Subject: Re: RE: An application of FCC approval A3LSWDS3310(S3310C) (PO)

Title : RE: An application of FCC approval A3LSWDS3310(S3310C) (P0)

GSM850

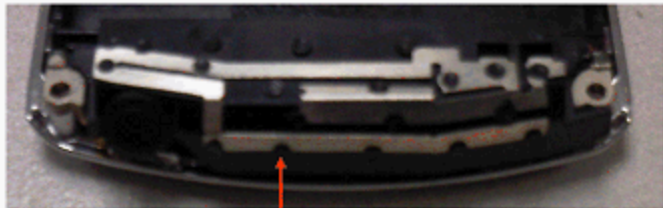
Can you confirm that the Head SAR is supposed to be low for GSM850, due to the antenna pattern? We will likely need an explanation for FCC regarding the low SAR for this 2W transmitter.

As you see following picture, S3310's antenna locate bottom of this phone.
and GSM850 pattern locate the base side, so GSM850 radiate downward.
For this reason, the GSM850 head SAR is low.
